Dear Vagner,

The study “Interannual Variations of Terrestrial Water Storage in the East African Rift Region” addresses an interesting topic and provides some valuable insights. However, several issues need to be addressed before the manuscript can be considered for publication. I recommend major revisions based on the following main points and some other minor comments presented below.

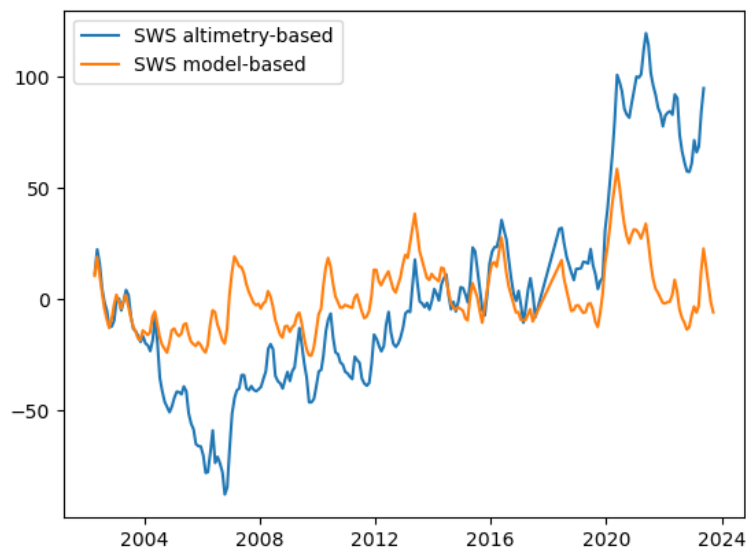
2. The study proposes a clustering approach to identify the East African Rift region as having similar interannual TWS dynamics. However, the justification for focusing on this specific region could be further improved by providing a stronger rationale for selecting this study area. The manuscript could highlight the East African Rift region's unique hydrological characteristics, ecological significance, or socio-economic importance.

We made our reasoning clearer in the revised manuscript and added further evidence for the particular relevance of the study area for both wildlife and humans, e.g., the region's lakes have been named one of the Global 200 eco-regions for conservation by the World Wide Fund for Nature (WWF), emphasising their importance for hydrology and ecosystems (Olson and Dinerstein, 2002). The shores of Lake Victoria are densely populated (one of the world's most populated areas, according to Gridded Population of the World, GPWv4.11). The population heavily relies on the water of lakes for domestic and industrial purposes (Juma et al., 2014).

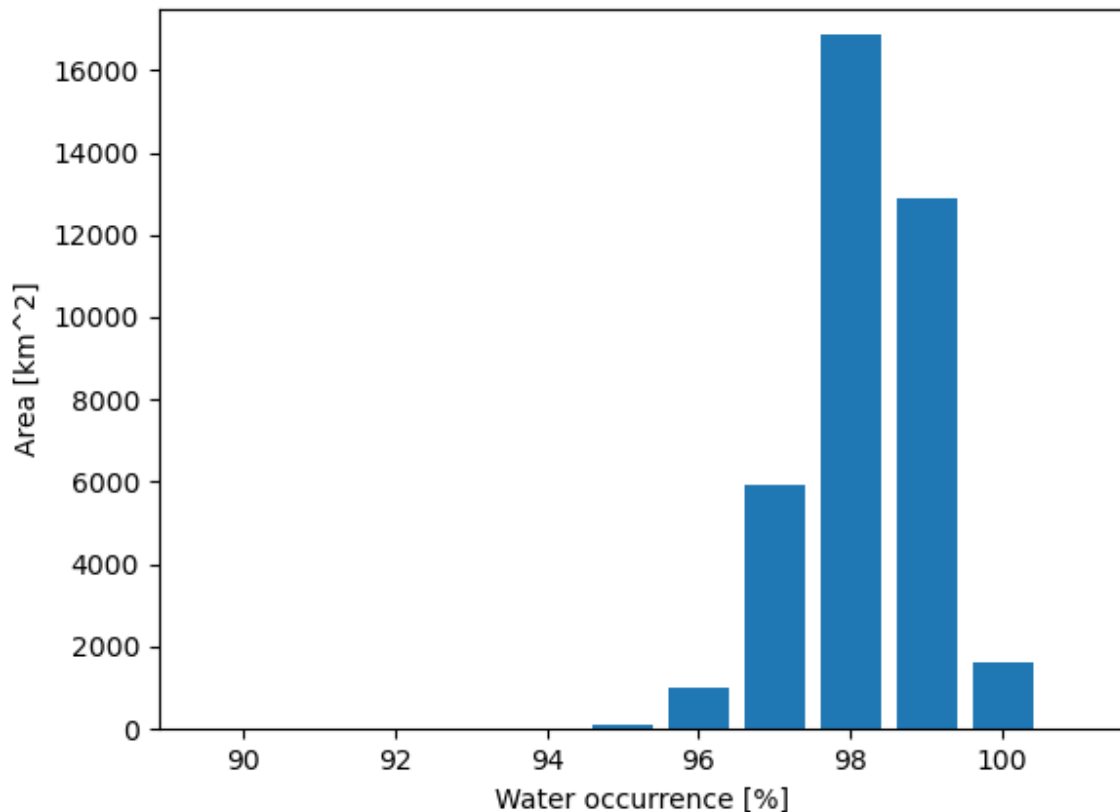
8. Lines 134-137: The description of the water occurrence map processing is unclear. Please provide more details on how the 95% occurrence threshold was determined and how it affects the estimation of lake surface areas.

By visually inspecting the lake's water occurrence maps and polygon outlines, we realised that even in the middle of the lake, pixels show a water occurrence of less than 100% but above 95%. See the following figure for Lake Albert. By ignoring this effect, the surface area would be underestimated.

Also, Pekel et al. (2016) documented that their water detection algorithm misses up to 5% of water pixels. That is due to partial cloud cover during the lake remote sensing observations, a particular problem in regions with regular cloud cover (such as the study region). The 95% threshold was found via a histogram of the water occurrences of pixels located clearly inside Lake Victoria (margin of 20km inside the GLWD polygon outline), see the following figure:

In the manuscript, we clarified the water surface processing and added the two figures above to the appendix.

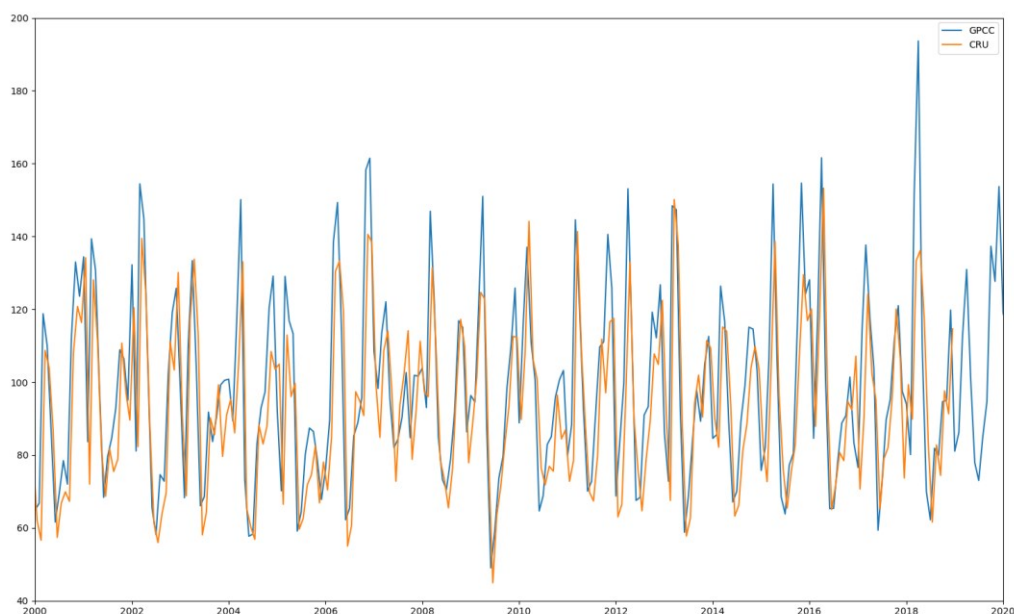
9. Lines 139-143: Please discuss the limitations of the surface water storage analysis based on a simplified relationship between lake level and area changes based on empirical cumulative distribution functions (ECDF). What could be the potential uncertainties it introduces in the storage estimates? For example, the monotonic and continuous relationship between lake level and area might not always be the case in reality. Lakes with complex bathymetry or irregular shorelines may exhibit non-monotonic or discontinuous relationships between level and area. However, the ECDF approach can handle outliers or anomalies in the input data more robustly than a linear regression used by Ferreira et al. (2018).

We found the ECDF approach well-suitable even for complex shorelines, even if it is based on the assumption of a continuous and monotonic relationship. We further assume that the lakes in our study do not show a hysteresis between water level and surface extent. We think this is a reasonable assumption as the lakes are not surrounded by extensive wetlands, which might introduce hysteresis behaviour. Unfortunately, we cannot further investigate

the assumption of a monotonic and continuous relationship between area and water level as we would need time-dependent area data for the lakes.

Overall, we estimate the uncertainty introduced by the ECDF method and its assumptions to be small compared to the uncertainty of altimetric water levels and surface water extent (see comment above).

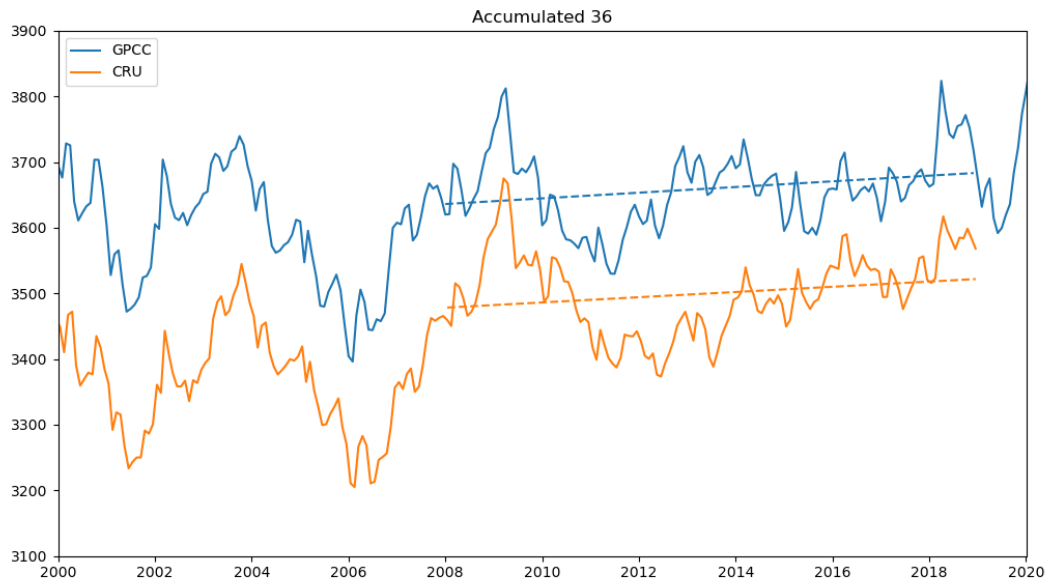
10. Lines 240-247: The discussion of the differences between the two SPEI datasets seems speculative. Please provide more evidence to support the claim that the divergence after 2008 is caused by differences in precipitation data rather than PET estimation methods.

Thanks for this comment. We accordingly had a more thorough look at the data and revised the presentation in the manuscript: We compared the two precipitation data sets used in the two SPEI data, i.e., GPCC and CRU precipitation, in the figure below (monthly time series of area-average precipitation over the study region).

Differences between the two data sets are clearly visible: monthly maxima tend to be higher in GPCC than in CRU, and in some years, the phase of the annual signal is slightly shifted (CRU being later than GPCC).

Further, we investigate the accumulated time series (following figure) with an accumulation period of 36 months (the same period used for SPEI). The dynamics of the two time series are quite similar, albeit with larger rainfall volumes for GPCC than for CRU.

We added the figure of the accumulated precipitation to the appendix and added to the text:
